AGENDA
ARCHITECTURAL REVIEW BOARD MEETING
Public Meeting Room, Village Hall
Tuesday, July 16, 2019
7:00 p.m.

- 3.2 Consideration and Discussion of Site Design, Building Elevations, Landscape Plans, Exterior Lighting, Parking, and Exterior Signage for a Proposed Hotel Building – 350 Knightsbridge Parkway (Knight Bridge Pky, LLC)

- The Architectural Review Board (ARB) reviewed the proposed wall sign variations and held a workshop on the proposed development plan for a new Home2 Suites by Hilton hotel building at 350 Knightsbridge Parkway on June 18, 2019. The ARB unanimously approved a motion to continue the public hearing at its next regularly scheduled meeting on July 16, 2019. The ARB also provided the petitioner with feedback regarding building elevations, building materials, and landscaping. The ARB's direction is summarized below:

Re: 350 Knightsbridge Parkway- Summary of Changes/ Modifications after June 18, 2019 ARB Meeting

A5.02

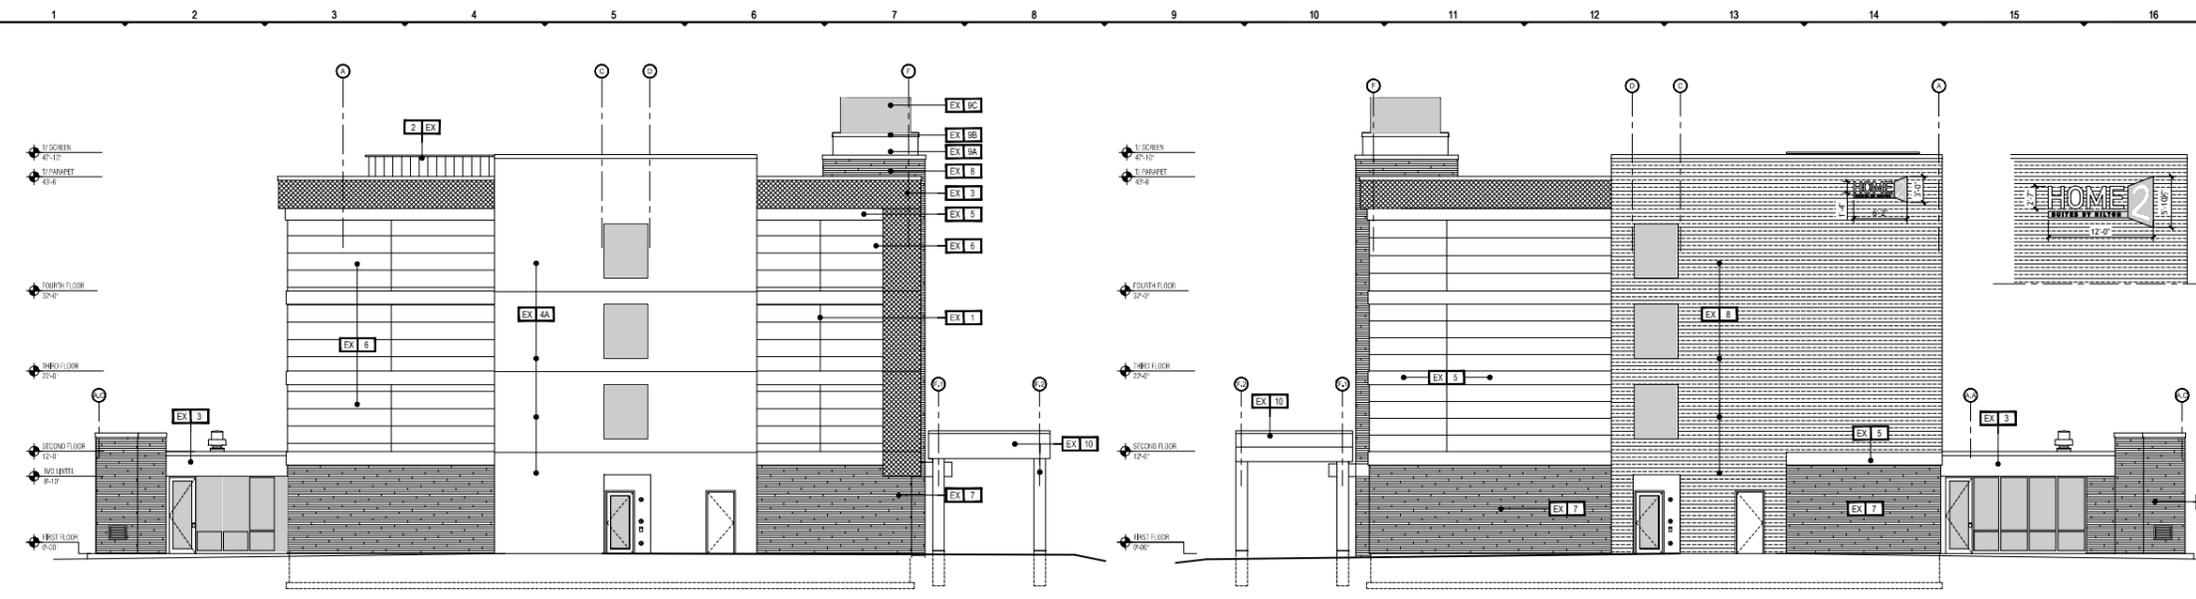
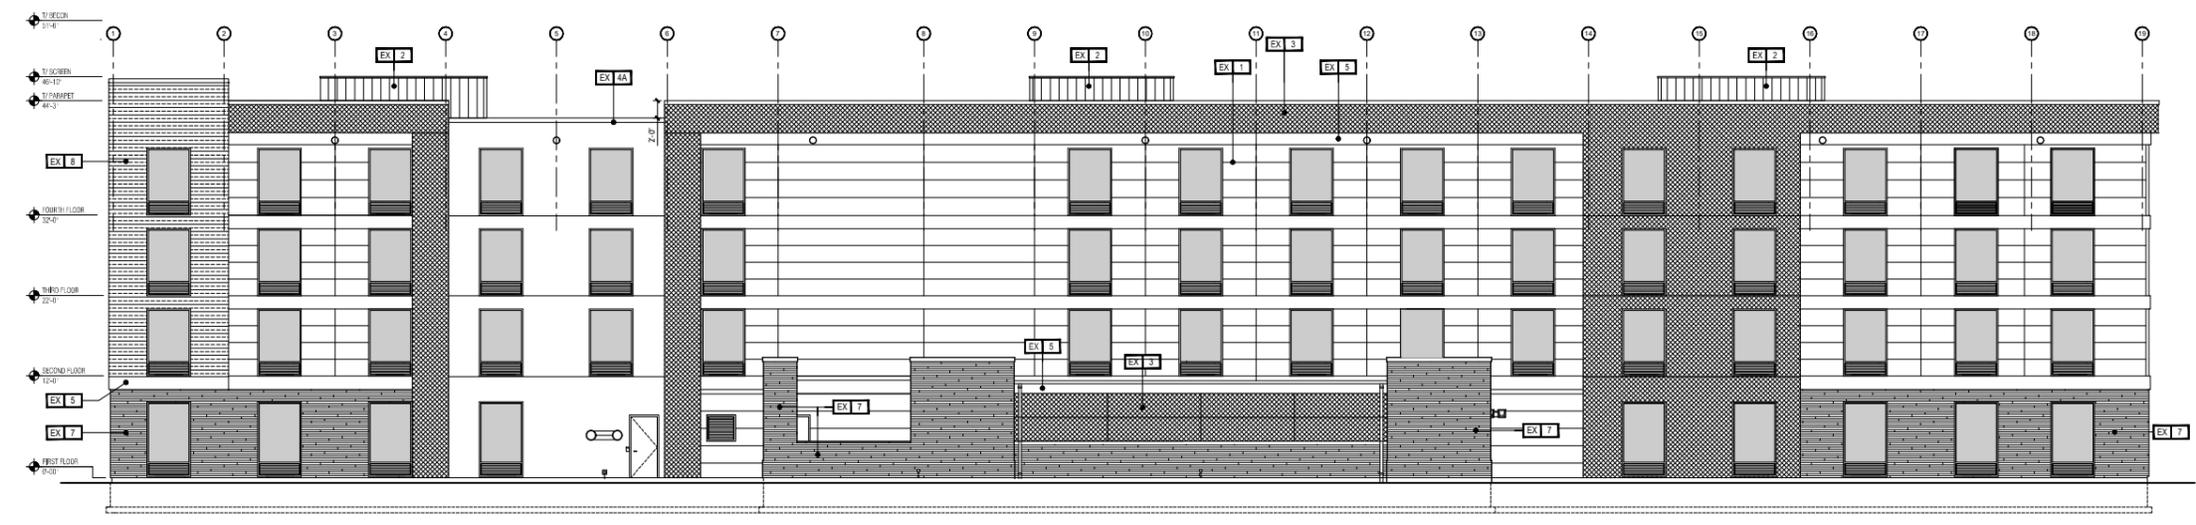
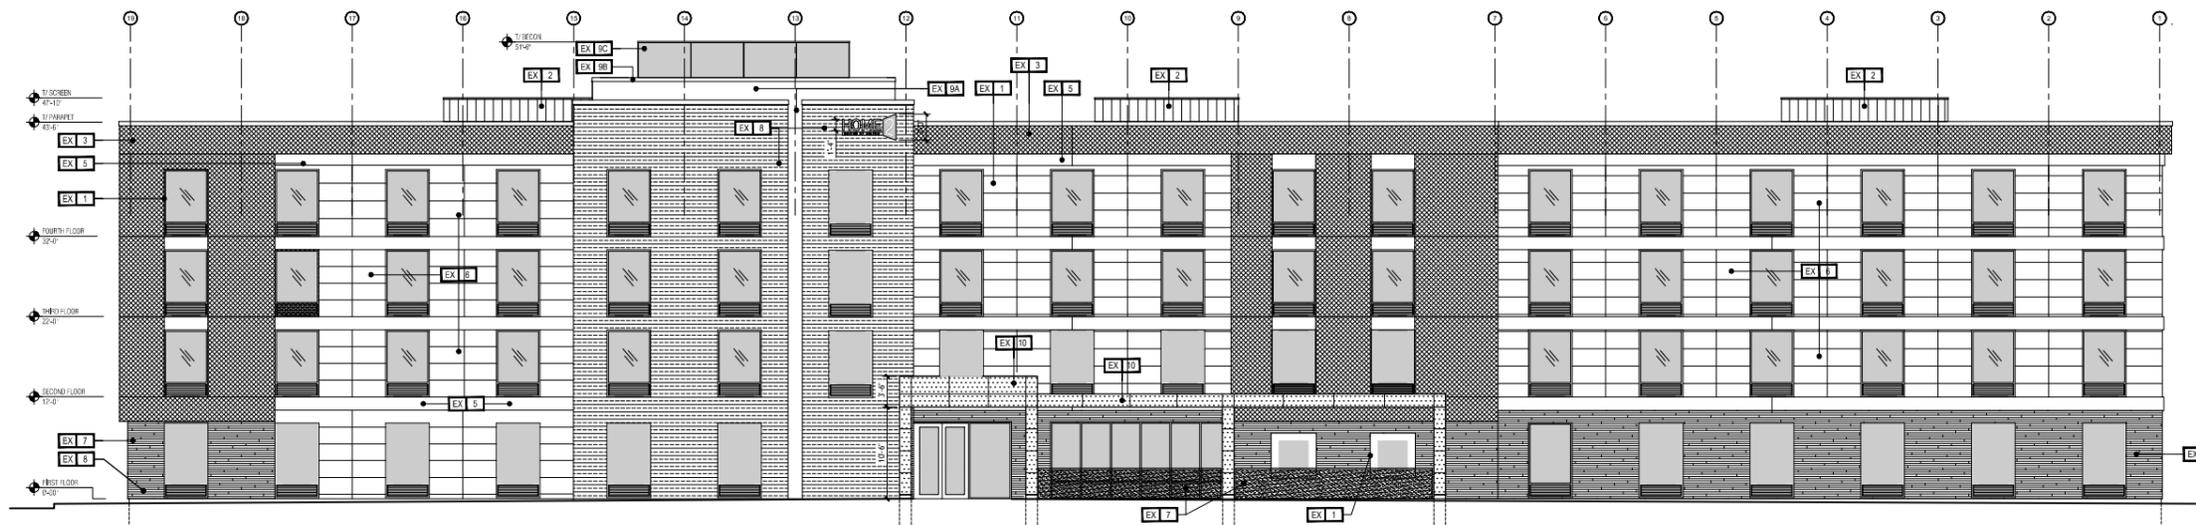
- Since the last ARB meeting, the petitioner has added more stone material at the northwest corner of the building to provide a "wrap" around the building. A similar design was applied at the southeast corner of the building. Additional stone material was added at the base of the building, at the main entrance, and along the east patio wall.

- The EIFS wrap has been modified in the renderings to more accurately depict the true color of the material (white with a blue-grey hue versus the stark white that was originally portrayed).
- The canopy structure also shows cladding over painted tube steel. The cladding material is shown to be “Trespa” panels with a silver-metallic color.
- The “beacon” feature has also be amended such that it is widened across three window bays. The green accent band has also been extended both horizontally and vertically.
- Staff requests the ARB’s consideration if further design enhancements are needed.

1. Modified the North Elevation, to steer clear from symmetry and static facade. Off center wall sign. Introduced more stone.
2. Modified West Elevation (left end), to wrap the stone from north elevation.
3. The white color EIFS shows the "true color" of white- which is slightly bluish- grayish color.
4. The canopy structure (columns and beams) to have cladding over painted tube steel., to make the entry more inviting and prominent. The cladding material shall be "Trespa" Panels- Silver Metallic color.

5. The beacon wall carrying the wall mounted wall, is widened over three bays of windows. This helps to show its preeminence as focal/ entry point. Additionally, due to the fact- the north facade being at 90 degree from the Kinghtsbridge Parkway, the widening of the beacon wall helps to comprehend main entry's presence better from the public road.
6. The white colored beacon on top of the roof to follow the widened stone wall below.

SHEET INFORMATION	
SIGNAGE DETAILS	
PAI # 19112.00	
A0.04

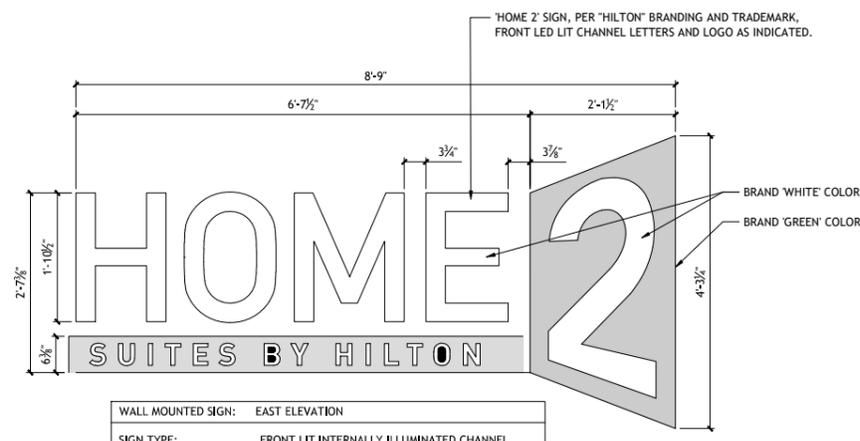
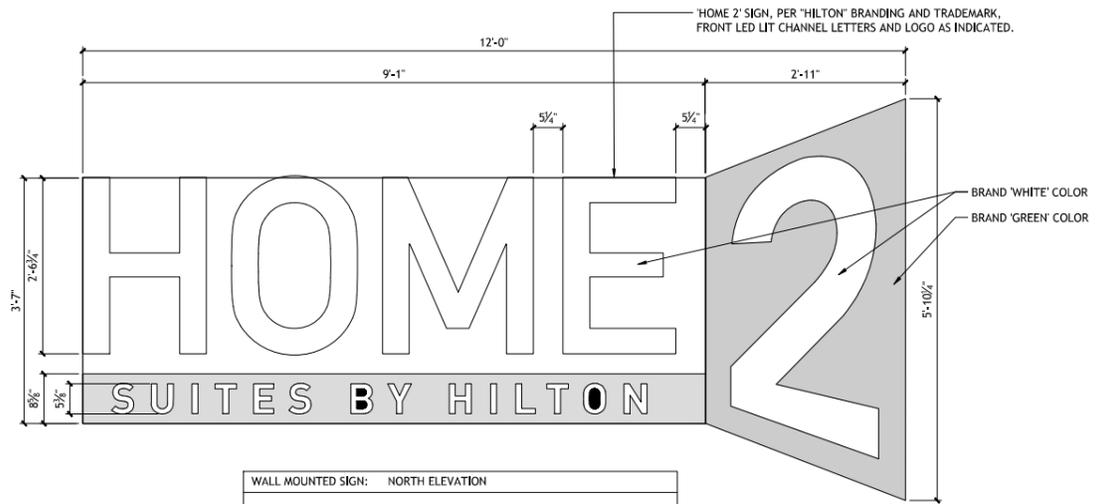
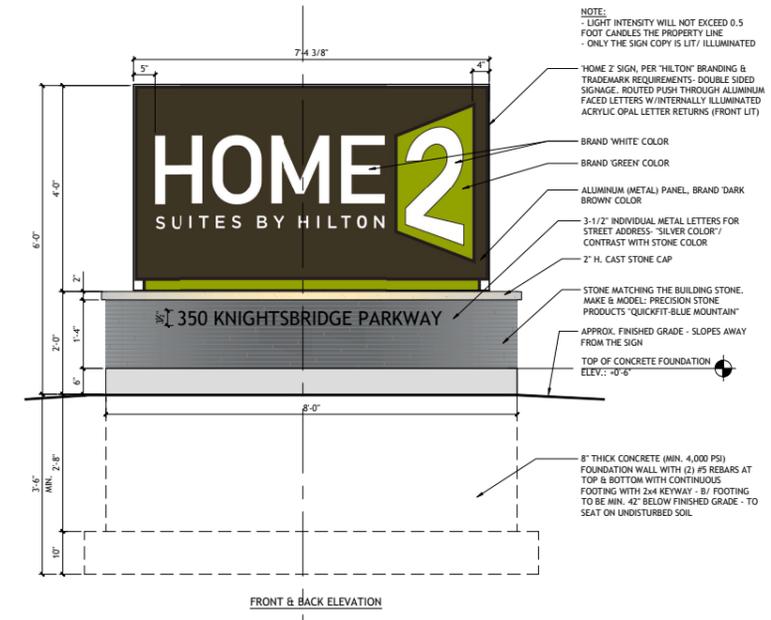
- Ground Sign: Since the last ARB meeting, the petitioner has adjusted the illumination of the ground sign to match the channel illumination style of the wall signs per the ARB’s direction. The petitioner has also offset the north elevation wall sign to provide for a more dynamic façade. The sign complies with Code.

1. Ground sign is front lit to match the illumination of the wall mounted signs
2. Signage width on the North Elevation is reduced to 12'-0" from 14'-0" per Van Vlissingen's request.
3. Drawing of Exterior Elevations per the code compliant wall sign size added.

SHEET:
DM1

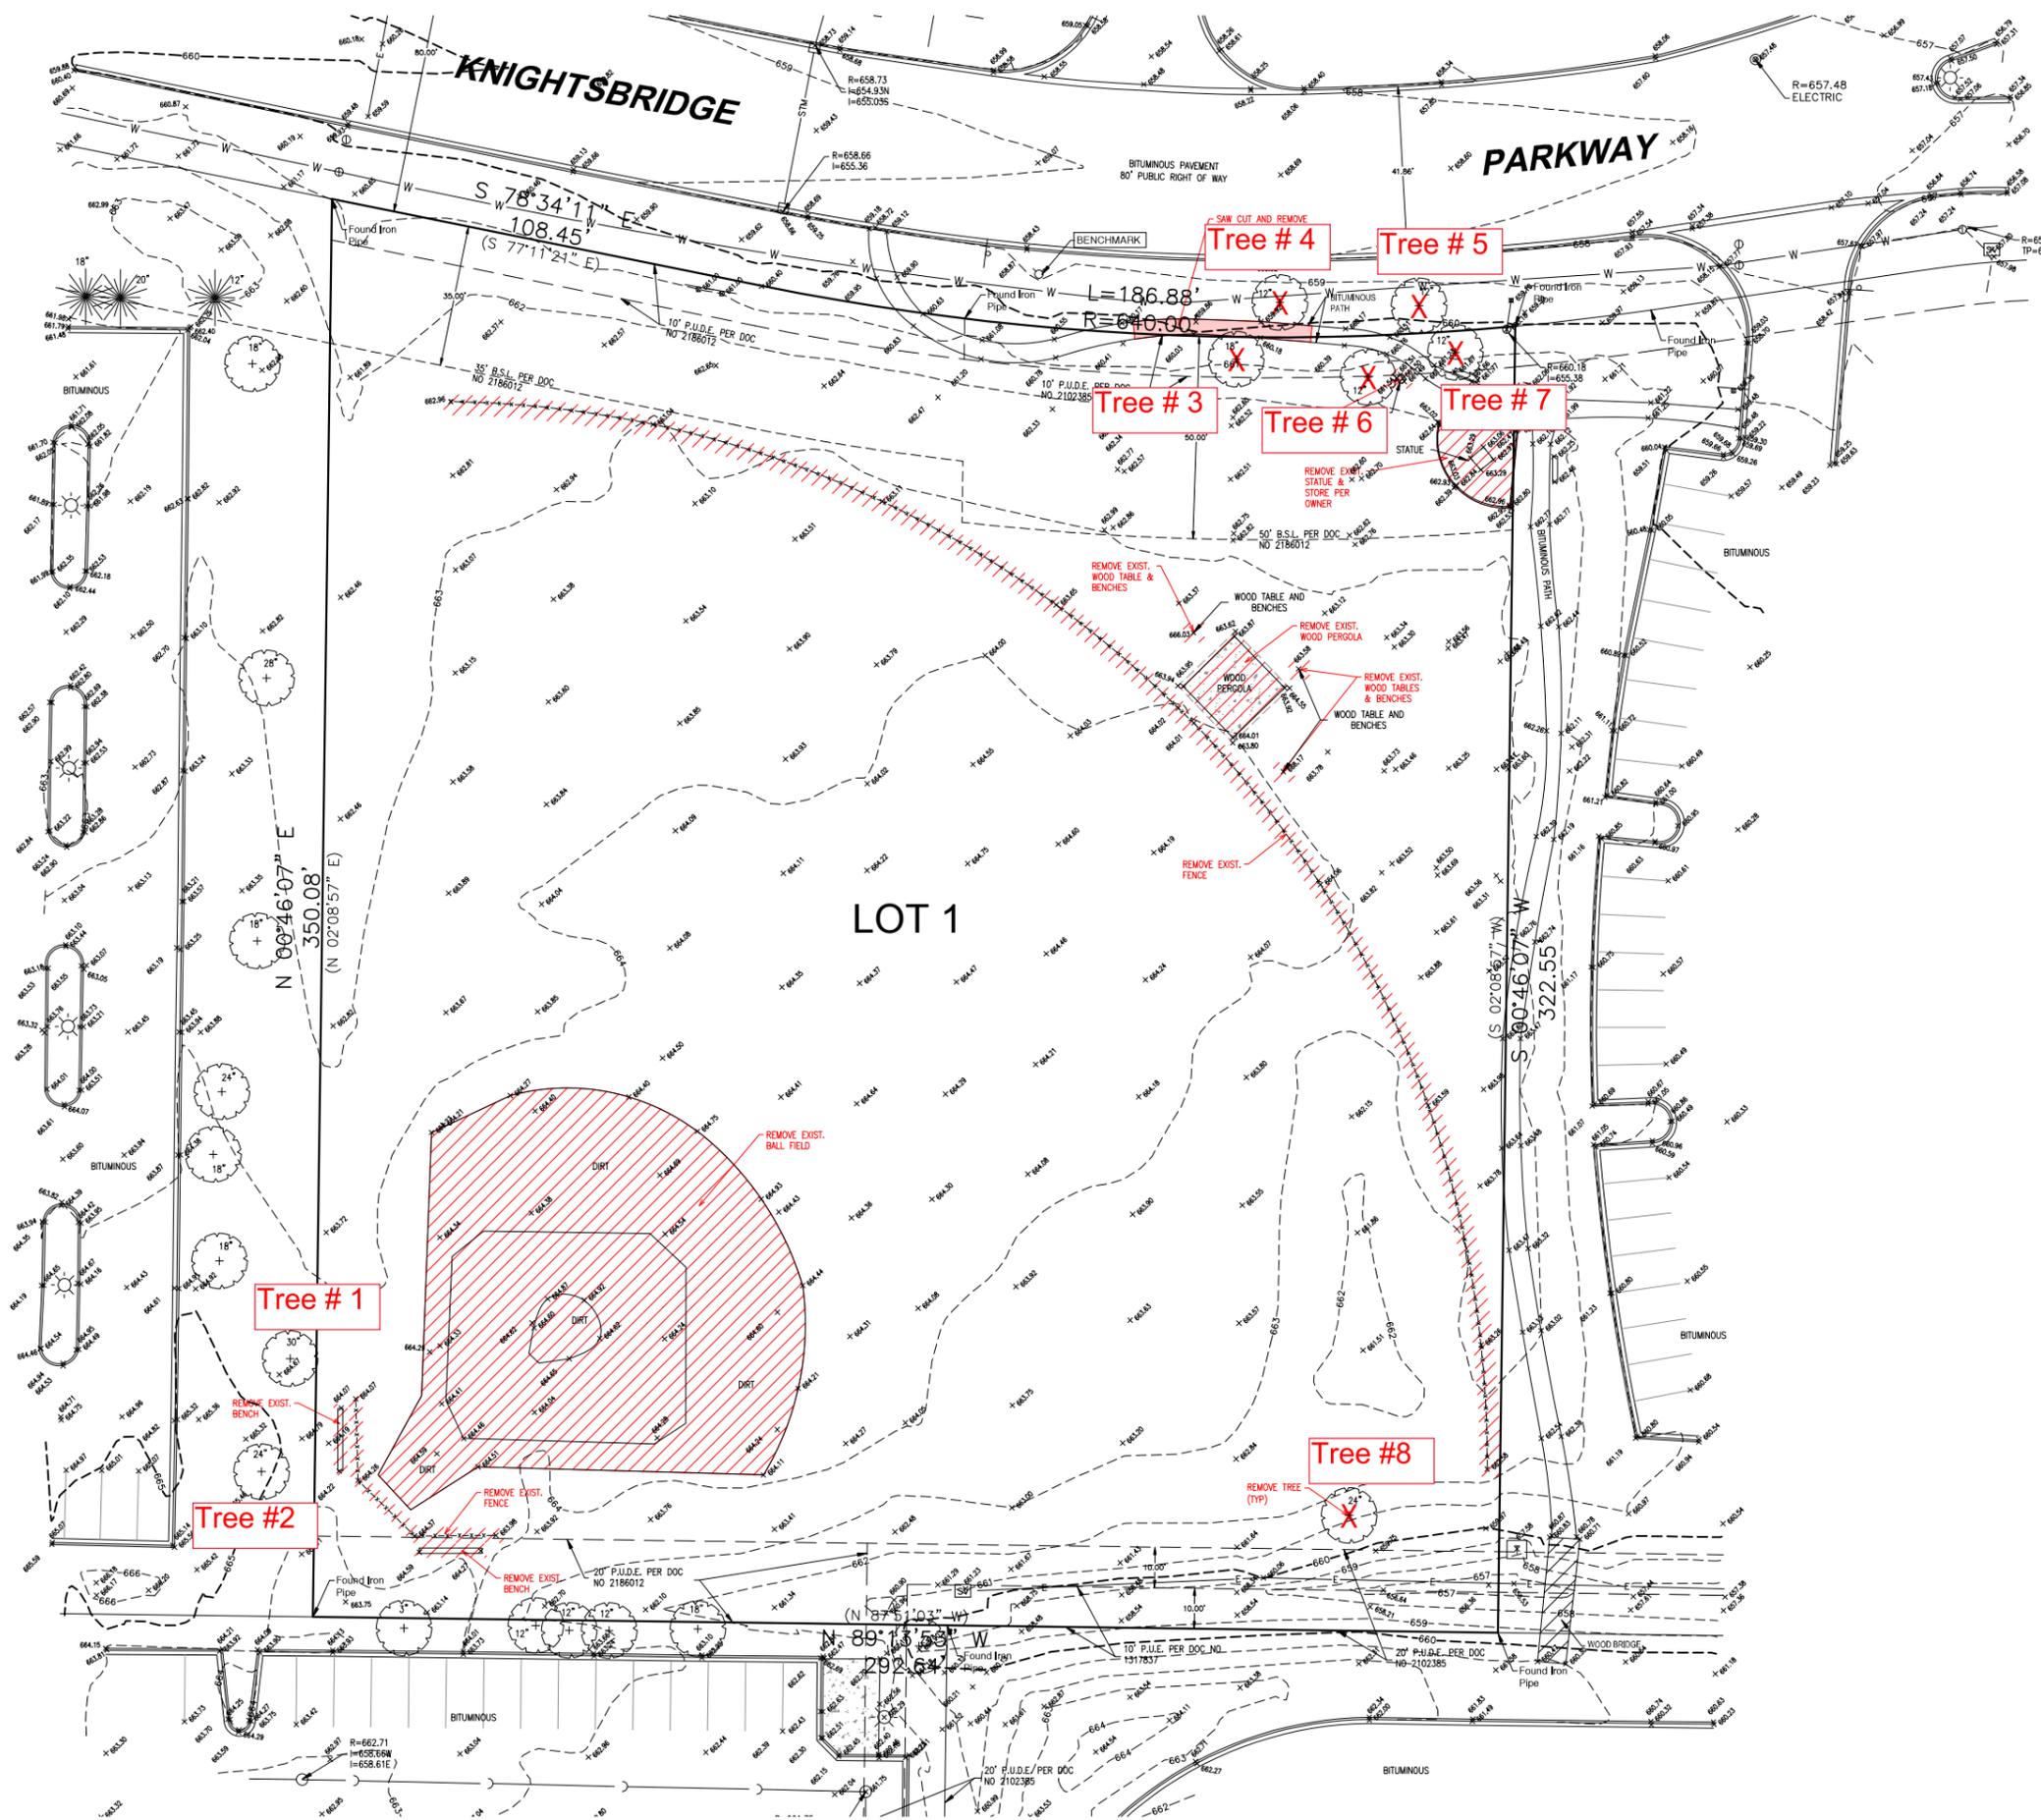
This memo summarizes the review of trees proposed for removal as shown on the Sheet DM1: Demolition Plan, dated March 1, 2019 (modified by GRWA 7/2/2019). The trees were numbered and identified on the attached sheet and described in the table below.. Species and conditions were assessed. The on-site trees consist of five (5) dead White Ash (*Fraxinus Americana*) and 1 White Mulberry (*Morus alba*). Two (2) off-site trees were reviewed as they are in close proximity to the project area. The off-site trees (Trees #1 & 2) are dead White Ash and are recommended for removal.
